LETTER NO. 167

Comment 167-1

Response 167-1

Proposal #1 ON LUCILE ST.

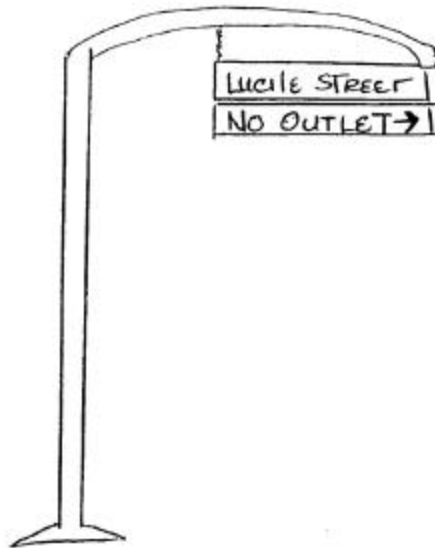
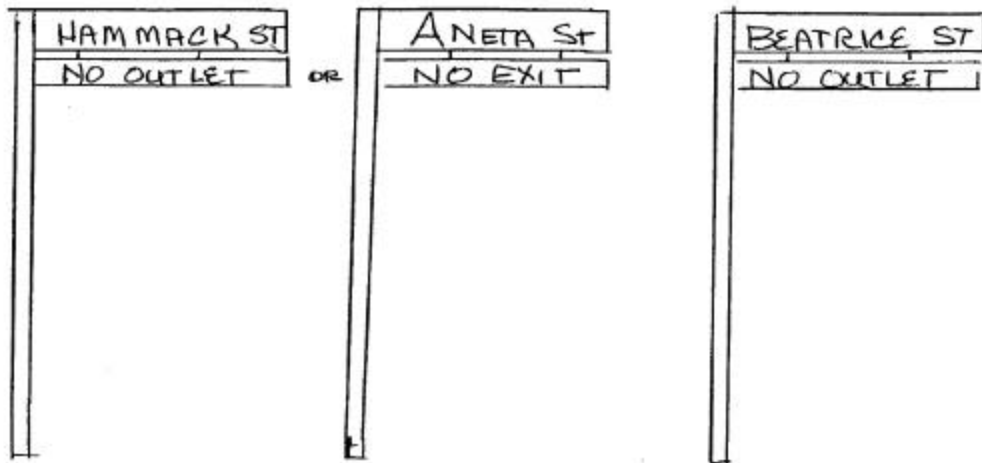
Knowing what the future plan of the area was going to become, the homeowners in this section of Los Angeles County, paid to have their streets all Cul-de-saced [sic] in 1985, completed in 1988. Therefore we have no through traffic. But we do have people that do not pay attention to the signs, speed down our streets thinking they can get through, then speed back out. There are truck drivers that ignore signs even load limit signs. Lucile Street is traveled more because it is a signal street. Our request is: On the overhanging sign that states its [sic] Lucile St we want an additional sign that says NO EXIT OR NO OUTLET on both sides so that drivers see it BEFORE they turn left or right into out [sic] street, and adding an arrow might help too. These

cars, trucks, and semi trucks, cement trucks, etc. are all trying to avoid the hectic corner of Centinela and Jefferson. More traffic into Playa Vista is effecting [sic] our lives, and it is only going to get worse. So correct it now! Signs are also needed on the street name signs for all four street [sic] , which does include Juniette St. I am enclosing a drawing of what our area needs.

The suggestions stated in this comment are current operational issues that are handled by the LADOT’s Operations office or the County Department of Public Works. The comment is noted and will be forwarded to the respective jurisdictions for their review and consideration.
